WINDER PRELIMINA

$E^{\frac{1}{2}}$ OF SECTION 29, T13S, **EL PASO COUNTY**

_
	COUNTY FILE NO.: SP-19-003	SHEET: 1 OF 10

Prelim plan V_4 redlines planning.pdf Markup Summary 2-4-2021

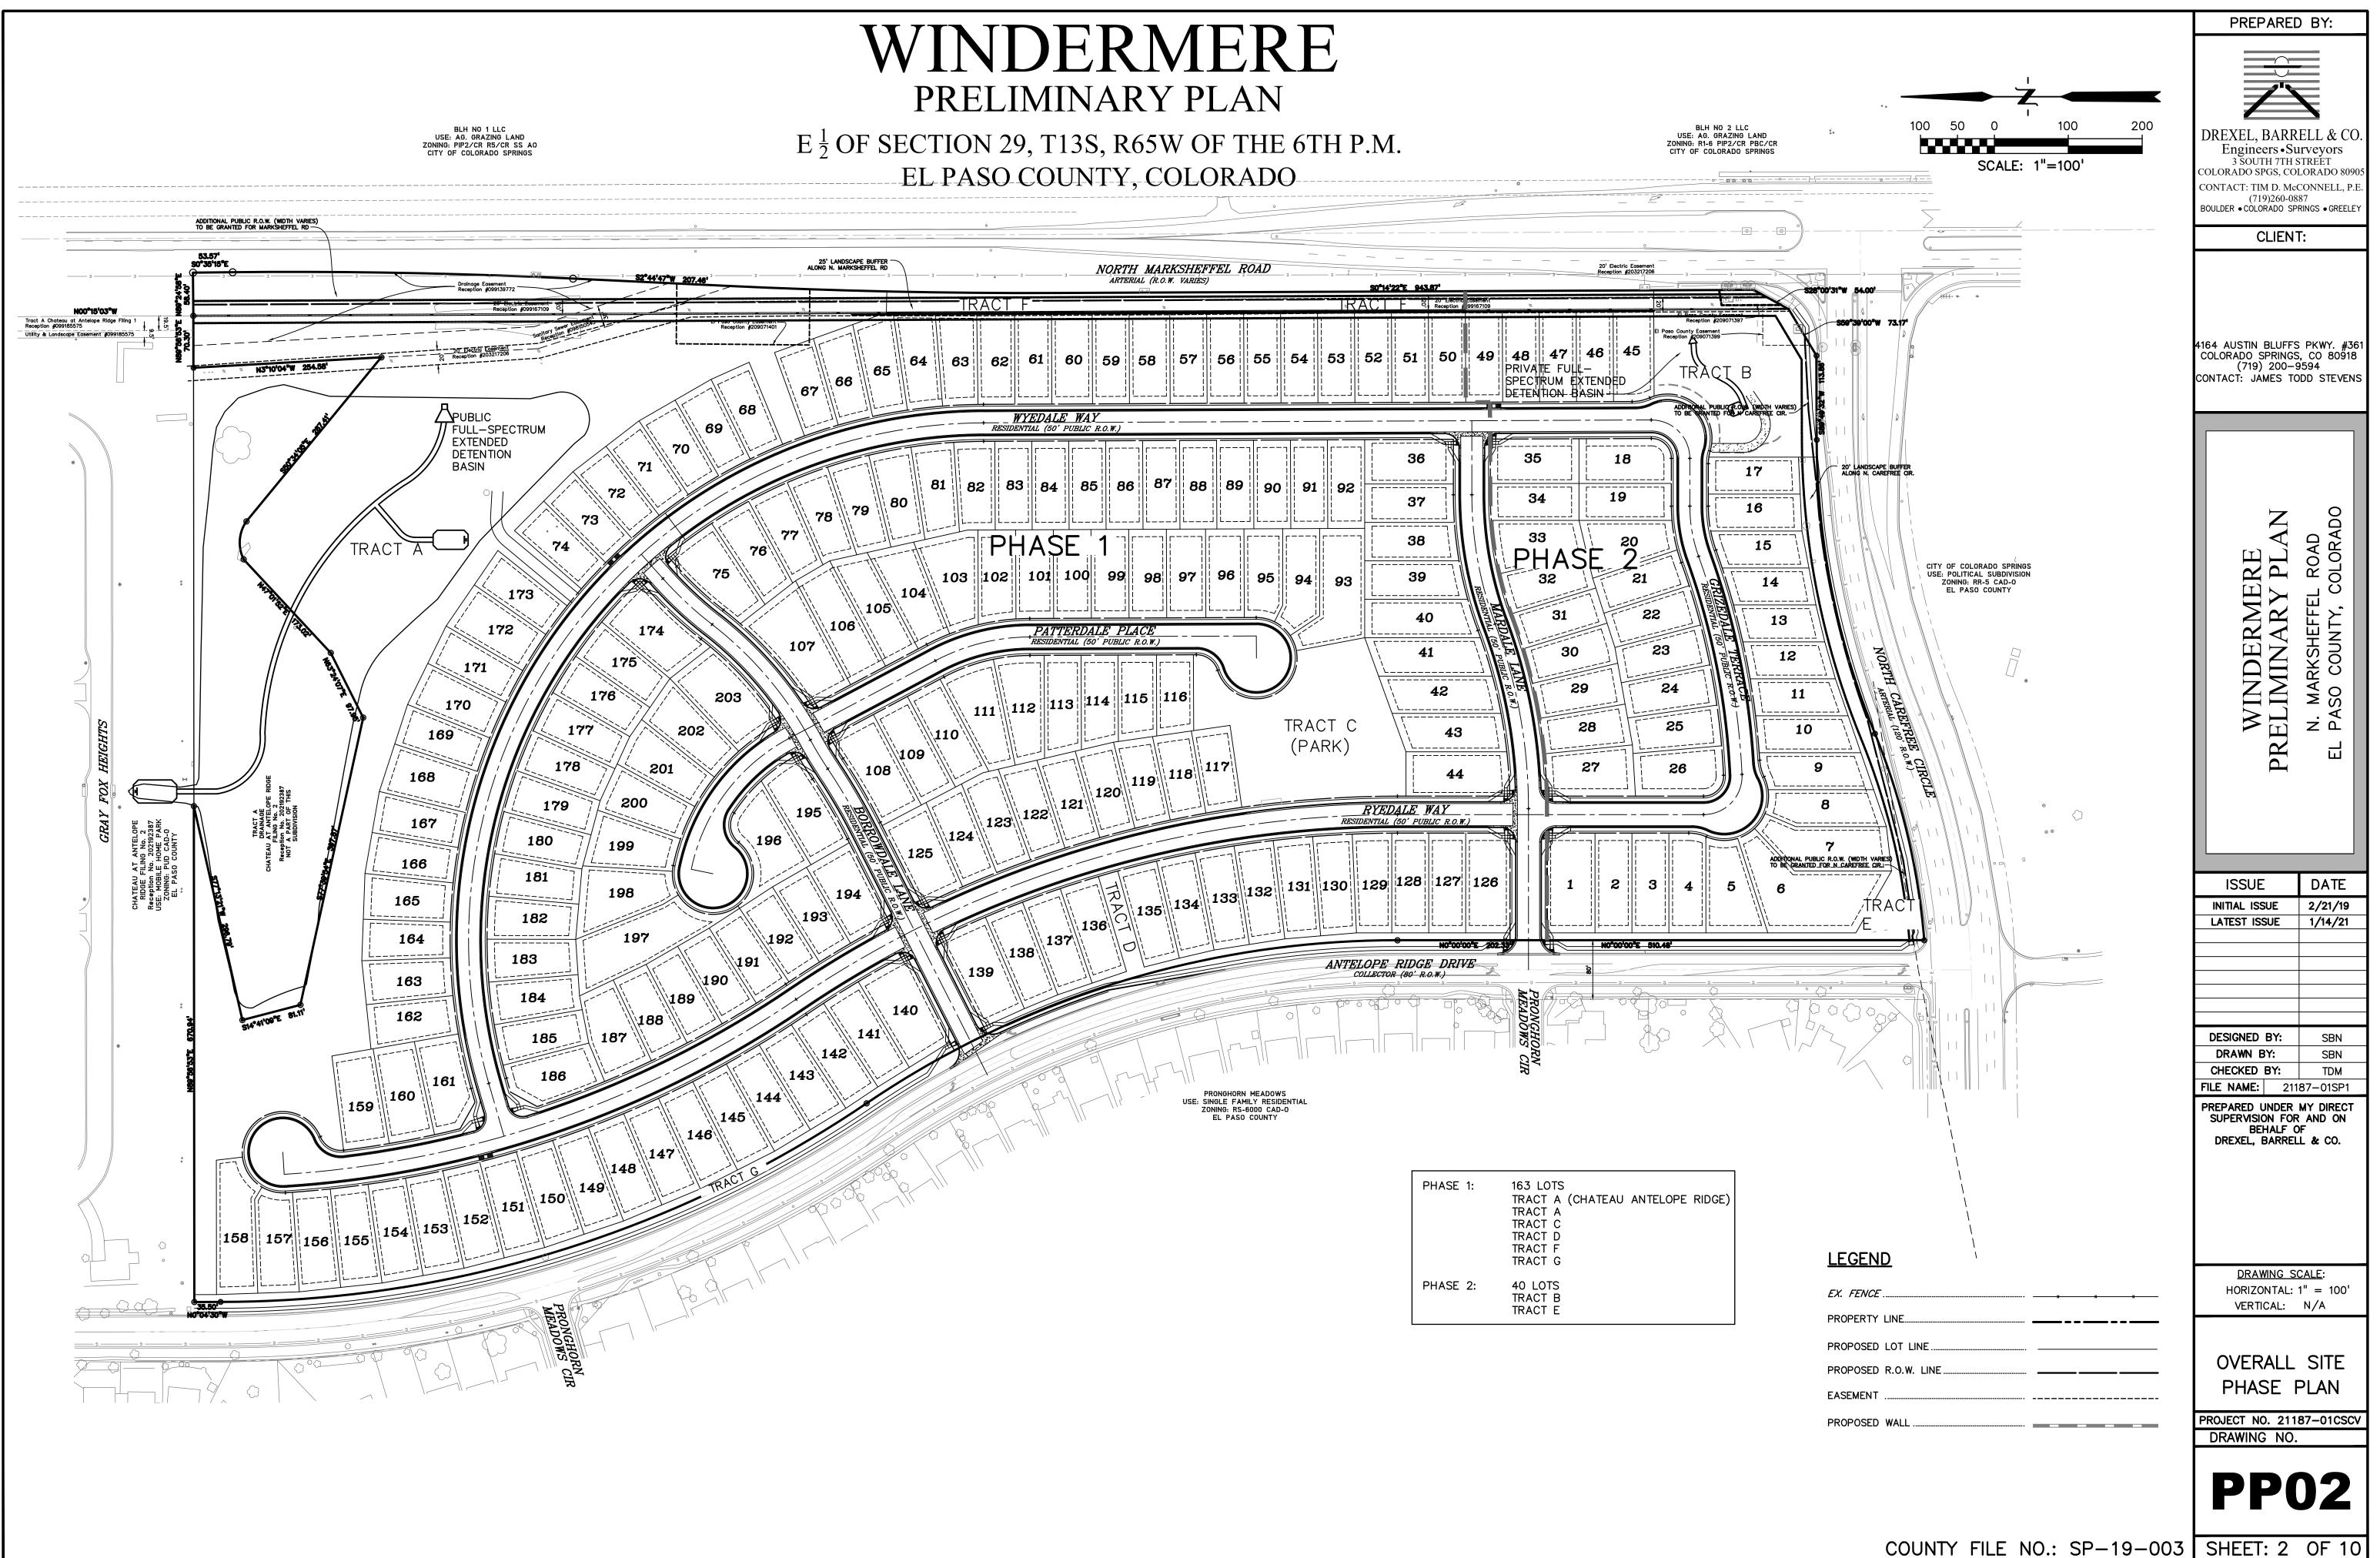
NERE		PREPARED BY:
RY PLAN		DREXEL, BARRELL & CO.
R65W OF THE 6TH P.M.		Engineers • Surveyors 3 SOUTH 7TH STREET COLORADO SPGS, COLORADO 80905
Y, COLORADO		CONTACT: TIM D. McCONNELL, P.E. (719)260-0887 BOULDER • COLORADO SPRINGS • GREELEY
BARNES RD		CLIENT:
OTELNA		4164 AUSTIN BLUFFS PKWY. #361 COLORADO SPRINGS, CO 80918 (719) 200–9594
JECT		CONTACT: JAMES TODD STEVENS
underdrain to be installed by, and	SHEET INDEX PP01 COVER SHEET	
EFREE CIR maintained by? They go into storm sewer so are they	PP02 OVERALL SITE PHASE PLAN	
accounted for in GEC plan and FAE Sound walls are like		7 8
to be installed and maintained by a District as is	PP06 PRELIMINARY UTILITY & PUBLIC FACILITY PLAN	
Perimeter roadway	rk PP07-PP10 PRELIMINART GRADING PLAN	ERE Y PLAN L ROAD COLORADO
since it will likely b the service plan co and needs - Is the	osts	
District not going to do CCR enforceme (no HOA)		NDERM MINAR Arksheffi county,

Add this note please as summarized from the 12/20 CGS comments

dsdparsons (11)	
THE TO BREAT THAT Y THAT'S THAT WITCH THAT AND A THAT A START	Subject: Callout Page Label: [1] 1 21187-01CV1 - DP01 Author: dsdparsons Date: 2/3/2021 4:14:34 PM Status: Color: Layer: Space:	19-471
	Subject: Callout Page Label: [1] 1 21187-01CV1 - DP01 Author: dsdparsons Date: 2/3/2021 4:17:12 PM Status: Color: Layer: Space:	underdrain to be installed by, and maintained by? They go into storm sewer so are they accounted for in GEC plan and FAE
	Subject: Callout Page Label: [1] 1 21187-01CV1 - DP01 Author: dsdparsons Date: 2/3/2021 4:20:29 PM Status: Color: Layer: Space:	Sound walls are likley to be installed and maintained by a District as is perimeter roadway landscape and park since it will likely be in the service plan costs and needs - Is the District not going to do CCR enforcement (no HOA)
TS) SPRING 2021 FAL 2021 update or remove these as final plat has to be propagad and the pr	Subject: Callout Page Label: [1] 1 21187-01CV1 - DP01 Author: dsdparsons Date: 2/3/2021 4:22:06 PM Status: Color: Layer: Space:	update or remove thesea final plat has to be processed and this has to goto PC and BOCC

Subject: Callout Page Label: [1] 1 21187-01CV1 - DP01 Author: dsdparsons Date: 2/4/2021 7:00:26 AM Status: Color: Layer: Space:	Add this note please as summarized from the 12/20 CGS comments
